**From:** Steven Gunn-Russell <Stevengr@whitepeakplanning.co.uk>  
**Sent:** 06 July 2023 16:27  
**To:** Niall Mellan  
**Cc:** Nick Brookman  
**Subject:** Dinting Vale HPK/2022/0456 - Transport  
**Attachments:** 2022 11 08 22 0456 PRow Plan(1).pdf; 20230706 Dinting Vale KCN link.docx; 20230705 Dintingresi tpcomments20220456.docx

**From:** Glen Donaldson (Place) <Glen.Donaldson@derbyshire.gov.uk>  
**Sent:** Thursday, July 6, 2023 3:43 PM  
**To:** [planning@highpeak.gov.uk](mailto:planning@highpeak.gov.uk)  
**Cc:** Steven Gunn-Russell <Stevengr@whitepeakplanning.co.uk>  
**Subject:** Dinting Vale HPK/2022/0456 - Transport

After having an internal meeting with the relevant colleagues at the County Council on 5 July 2023, the following highway concerns we identified:

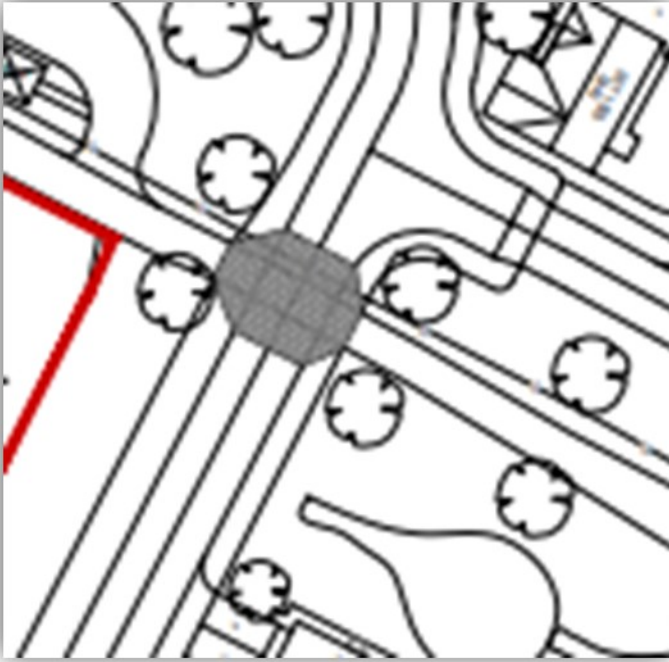
I am also aware of the requirements of the 'Inclusive Mobility' DFT 2022 which States: *'Generally, pedestrian environments should be level, which means that there should be no gradient in excess of 1 in 60. Effort should be made to ensure that the route is smooth, since even small dips or gaps in paving points might present a hazard such as to people who use a stick or a crutch. If a level route is not feasible, then gradients should not exceed 1 in 20. (A slope steeper than this is generally defined as a 'ramp'). Even if a pedestrian route has no slopes in excess of 1 in 20, it is important that there are level sections, or 'landings', at regular intervals. This is to provide people with an opportunity to rest; where possible accessible seating should be provided on such landings. A level landing should be provided for every 500mm that the route rises. The length of each landing should be equal to at least the width of the ramp'*

LTN/120 states: *'5.9.7 Unlike motor traffic, human physiology means that people can cycle steep gradients that are fairly short but are not capable of maintaining high levels of effort for longer distances. Cycle routes should therefore, where possible, be designed in such a way that the steepness and maximum length of longitudinal gradients meets the requirements of Table 5-8'* with Table 5-8 having a maximum gradient of 5% (1:20).

The County Council must be mindful of all highway users, so the levels must be reassessed and conform with the 1:20 requirement.
